ACCELERATED DISTRIBUTION DEMONSTRATION SYSTEM

SUBJECT: Provides response to NRC request for addl info re low upper shelf toughness fracture analysis of reactor vessels for load level A & B Conditions.

Re: Turkey Point Units 3 and 4
Docket Nos. 50-250 and 50-251
TAC Nos. M68249 and M55042
Low Upper-Shelf Toughness Fracture Analysis
of Reactor Vessels for Load Level A & B Conditions
Response to Request for Additional Information

REQUEST FOR ADDITIONAL INFORMATION (RAI)
REGARDING

Figure 4-22 J-R Model and Unirradiated HSST Data Comparison

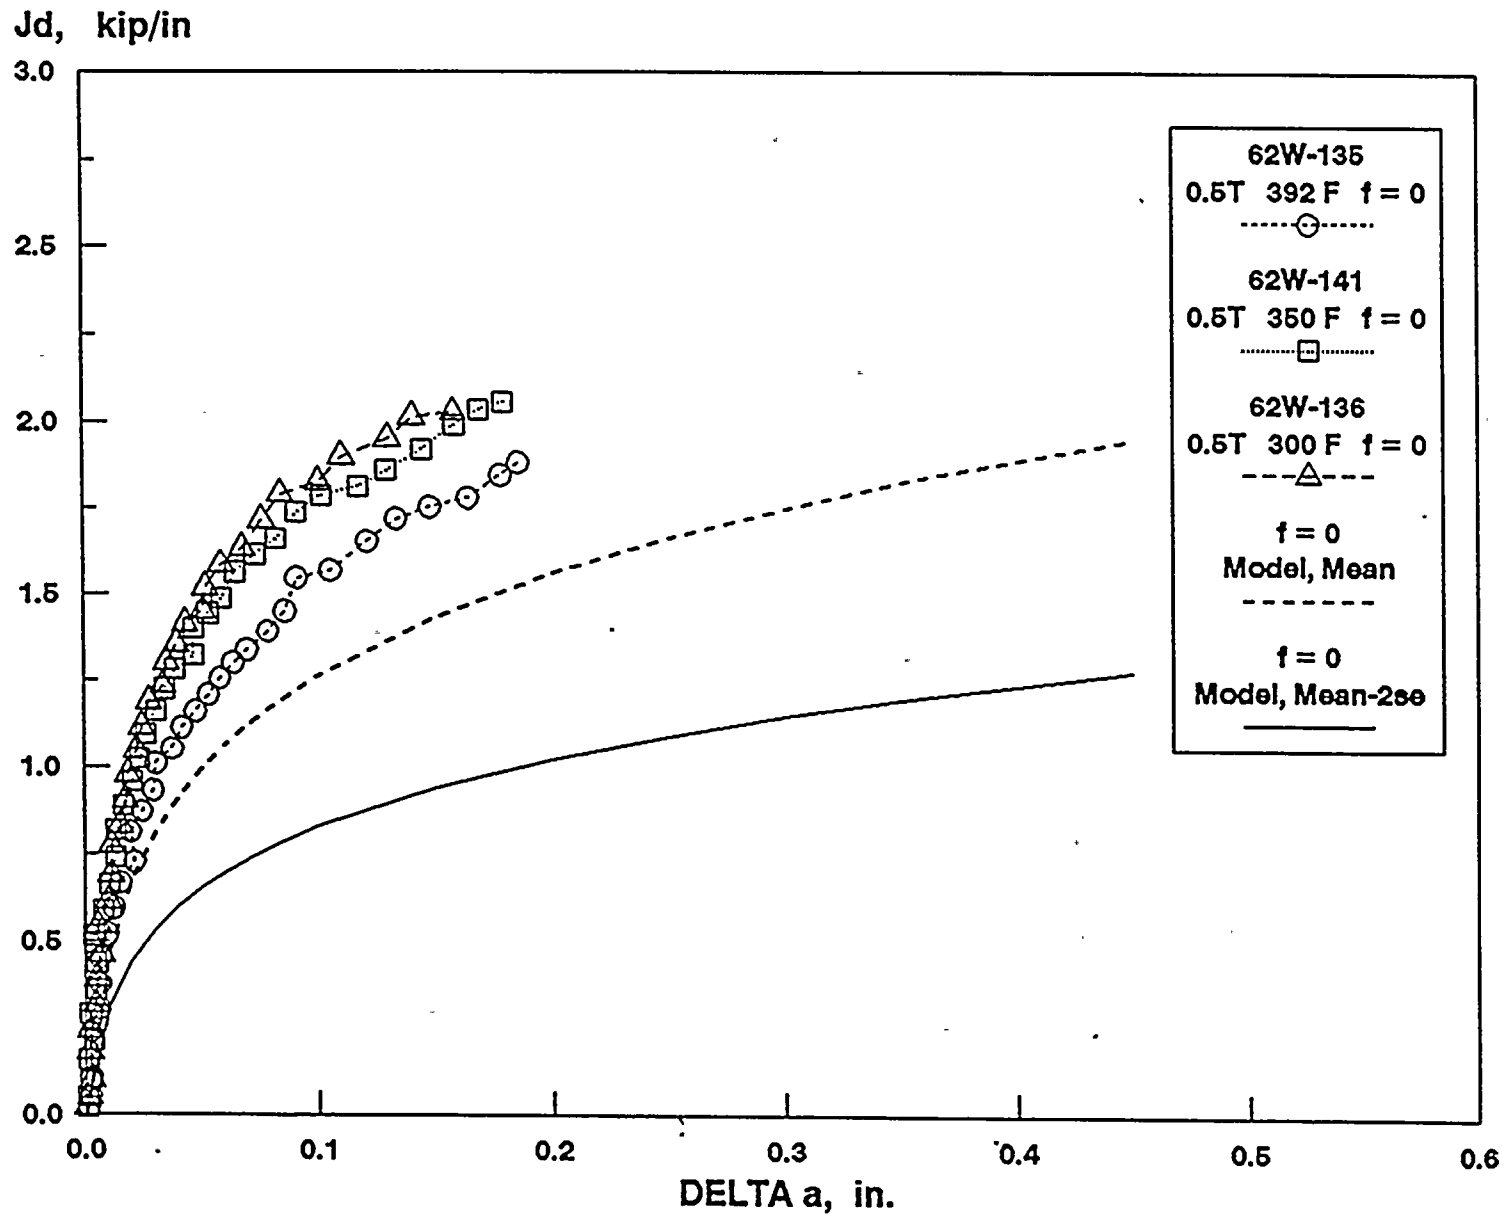
3. Explain the relationship between the irradiated HSST and the J-R model curves in Figures 4-22 and 4-23.

Attached clearer figures are to replace Figures 4-22 and 4-23. Since J_H is not used in this analysis, J_H - Δa curves are deleted. The text on pages 4-10 and 4-11 is modified as follows:

In Figure 4-22, three selected unirradiated SA-1101 J-R curves and the 4T CT irradiated specimen data J-R curves are shown with a mean and a lower bounding J-R curves predicted by the model equation for unirradiated material ($f = 0$). It is obvious that SA-1101 is relatively tougher material in Mn-Mo-Ni/Linde 80 weld metal. The predicted mean curve for unirradiated material is much lower than the irradiated material curve. There is only one irradiated CT specimen of SA-1101 available from the HSST data set, i.e. 62W-25, a 4T CT specimen with fluence of 1.4×10^{19} n/cm², tested at 350 F. This material J-R curve was compared with the model predicted curves as shown in Figure 4-23. It is apparent that this model is very conservative for this application. There exists a factor greater than 3 on J values between the test data and the lower bounding model curve. The same J-R data points are plotted against model curves with the same fluence as the 4T CT specimen in Figure 4-23.
